**PARTICLE MEASUREMENT PROGRAMME (PMP)**

*Prepared by Ricardo Consulting Engineers on behalf of the UK Department for Transport for presentation at the special informal meeting of the GRPE held in Geneva on 15 September 2003.*

**DISCUSSION DOCUMENT: DRAFT AMENDMENTS TO REGULATION NO. 49.**

Note: The following pages contain commentary on certain annexes of Regulation 49 with respect to their amendment to take account of the new measuring procedures explored during the UK contribution to the Particles Measurement Programme. Working Document 7, distributed at the Special Informal GRPE held on 15 September 2003, represented a consolidation of both unaffected text and detailed recommendations for amendment. This summary document does not contain unnecessary sections of unaffected text but retains all of the points raised in the full Working Document 7.

Figure 22 - Double dilution system (full flow system only)

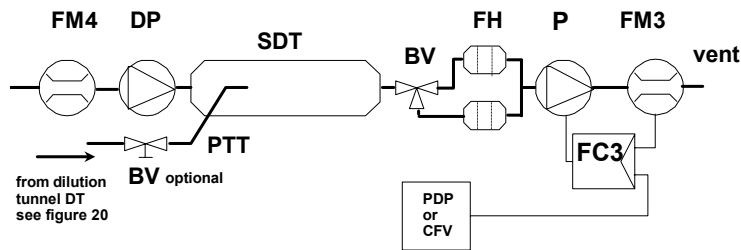
The double or secondary dilution system to be used in conjunction with a full flow dilution system is shown in Figure 22.

~~In this Regulation, the double dilution system (Figure 22) of a full flow dilution system is considered as a specific modification of a typical particulate sampling system as shown in Figure 21. The double dilution system includes all important parts of the particulate sampling system, like filter holders and sampling pump, and additionally some dilution features, like a dilution air supply and a secondary dilution tunnel.~~

A sample of the diluted exhaust gas is transferred from the dilution tunnel DT of a full flow dilution system through the particulate sampling probe PSP and the particulate transfer tube PTT to the secondary dilution tunnel SDT, where it is diluted once more. The sample is then passed through the filter holder(s) FH that contain the particulate sampling filters. The dilution air flow rate is usually constant whereas the sample flow rate is controlled by the flow controller FC3. If electronic flow compensation EFC (see Figure 20) is used, the total diluted exhaust gas flow is used as command signal for FC3.

Figure 23 - Particle Sampling System

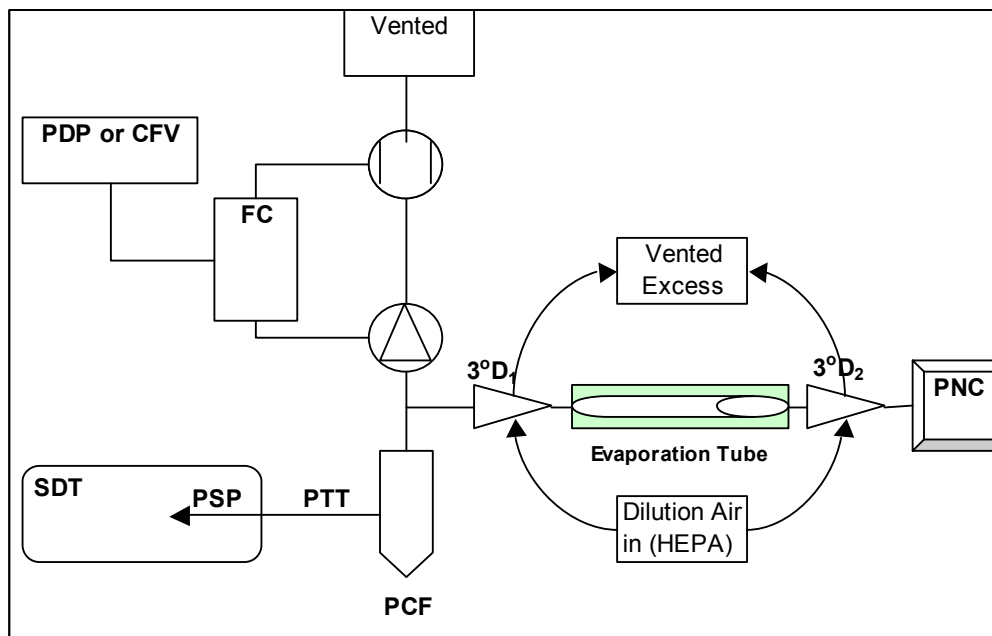
Figure 23 contains a detailed description of the recommended dilution and sampling systems required for particle measurement. Since various configurations can produce equivalent results, exact conformance with these figures is not required. Additional components such as instruments, valves, solenoids, pumps, and switches may be used to provide additional information and coordinate the functions of the component systems. Other components which
